# Product Change Notification (PCN)

PCN Number	508845	Date Issued	September 01, 2020
Reason for Change	Change to Product		
Change Type Description	This letter is to inform you that changes are being made to the part(s) identified in this Notice. The change may affect the fit, form, function or appearance of the parts, or it may result in a change to the specification. The pictures below show an example of the possible differences.		
Reason for Short Notice	Corrective Actions		
Assessment of Change	Dimension analysis		
Internal Molex Qualification Date	May 08, 2020		
Sample Availability Date (Changed Part)	May 08, 2020		
Planned Implementation Date	September 01, 2020		
Method of Identifying Change	Factory order number

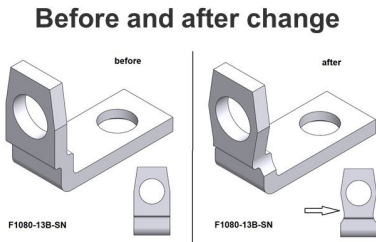
- We are changing the sub-product element form in order to meet our product conformance;
  - A sub-product element known as a metal angle plate is getting changed. This metal angle plate was sticking to the hoods of the connector and was getting pressed in the current design. This is undesirable. Cutouts for reverse use are added. Change of the outer geometry to enable reverse application in the connector is also enabled.
- **Product Impact**
  - There is impact to form/appearance of the product
  - No impact on Function and Fit
- **Part Number Impact**
  - See attached impacted parts list
- Qualification Reports and samples available upon request after the date shown above
